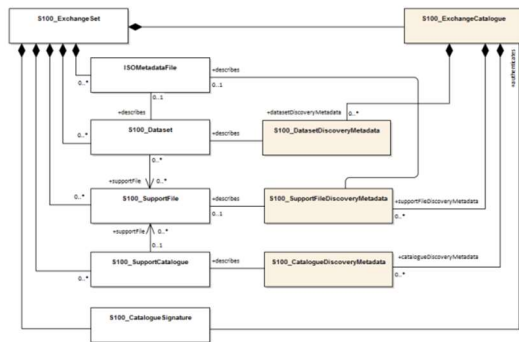
1	2	(3)	4	5	(6)	(7)	
Component	CO <sup>1</sup>	Clause No./ Subclause No./ Annex (e.g. 3.1)	Paragraph/ Figure/Table /Note (e.g. Table 1)	Type of comment <sup>2</sup>	Comment (justification for change) by the CO <sup>3</sup>	Proposed change by the CO	Secretariat observations on each comment submitted
PS	GER	10.6	10.6		<p><b>10.6 Unknown Attribute Values</b></p> <p><i>When a mandatory attribute code or tag is present but the attribute value is missing, it means that the producer wishes to indicate that this attribute value is unknown. Missing mandatory attributes must be “nilled”.</i></p> <p>Mandatory or not? Making attributes mandatory reflects the need of essential information. If a certain value is missing the producer needs to investigate.</p> <p>If attribute information could be “nilled” the attribute doesn’t seem to be important enough to be mandatory.</p>	<p>Either consider the removal of the words “mandatory” in 10.6. and check complete PS if all mandatory attributes do not have “volunteer” information.</p> <p>Or search for these mandatory attributes and consider to remove the mandatory status.</p> <p>Germany prefers to keep the mandatory attributes and make all included values mandatory, too.</p>
